Groundwater Application Review Summary Form

Application # G- 18826

To: Kristopher Byrd, Well Construction and Compliance Section Manager
From: Joel Jeffery, Well Construction Program Coordinator
Subject: Review of Water Right Application G-18826
Date: November 26, 2019

TO: Water Rights Section Date November 15, 2019
 FROM: Groundwater Section Karl Wozniak
 Reviewer's Name
 SUBJECT: Application G- 18826 Supersedes review of _____
 Date of Review(s) _____

Water Well Statistics T8S/4W-4

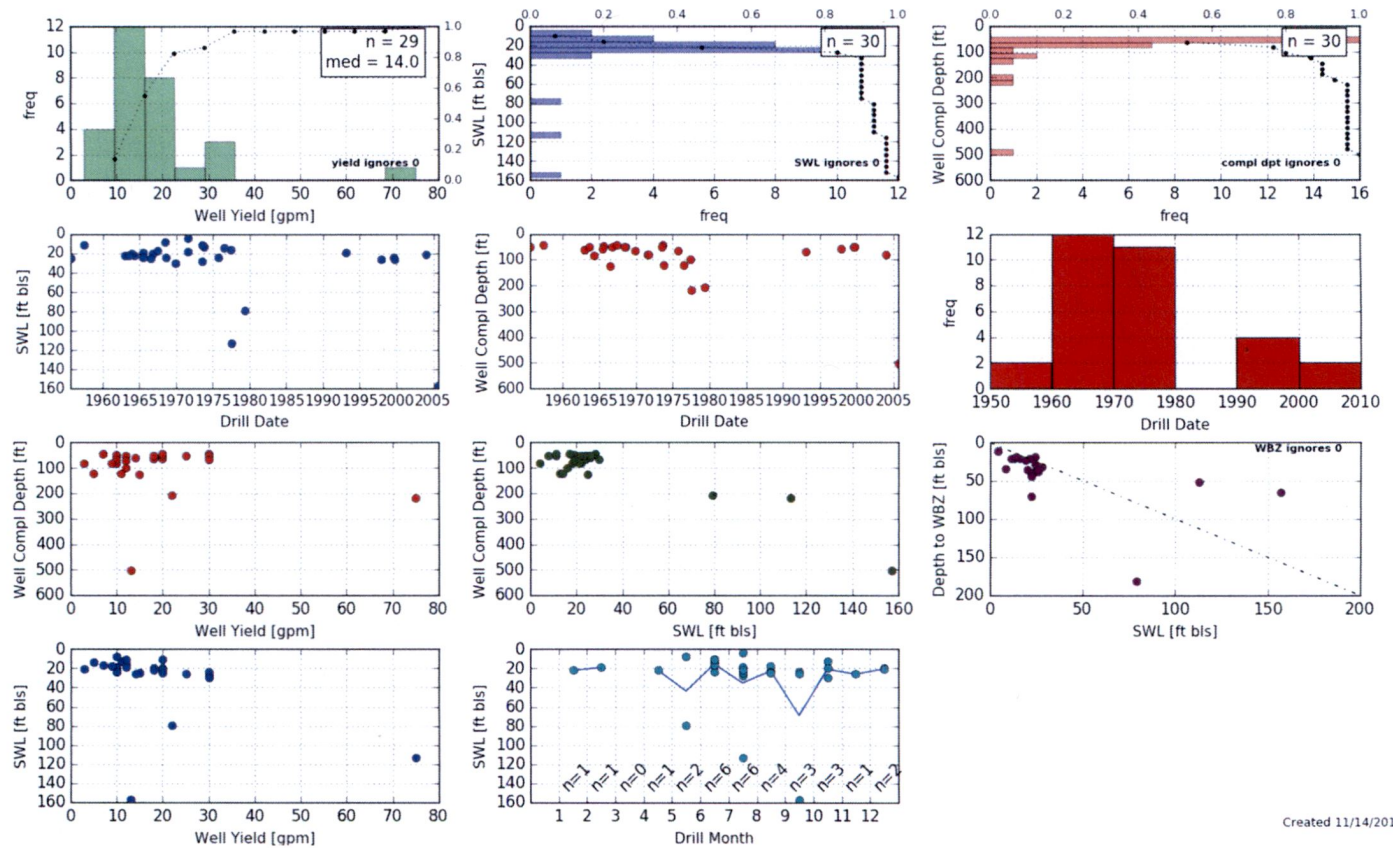
Irrigation and domestic well density is low in the surrounding area on the terrace. Three nearby permitted irrigation wells are located about 0.25-0.33 mile to the southeast. Several dozen developed tax lots, ranging from ¼ to 8 acres occur immediately to the east on the terrace and one occurs immediately to the west. Some of these tax lots are likely to depend upon domestic wells from the alluvial aquifer system but all are also within the footprint of the Rickreall Community Water Association domestic and quasi-municipal water rights under permits G-11977 and G-17497 (not shown on map). Low well yields, aquifer confinement, and a thin aquifer all speak to some concern about potential well interference from the proposed use but the overall likelihood of substantial interference is considered to be low because of the low proposed pumping rate. Nevertheless, the year-round use and high duty associated with a nursery right indicate that water-level monitoring and water-use monitoring would be prudent in the subject wells if the Department issues a permit. No active observation wells are located within the local area but nearby inactive observation wells (see attached hydrograph) suggest that water levels were stable between 1962 and 1991.
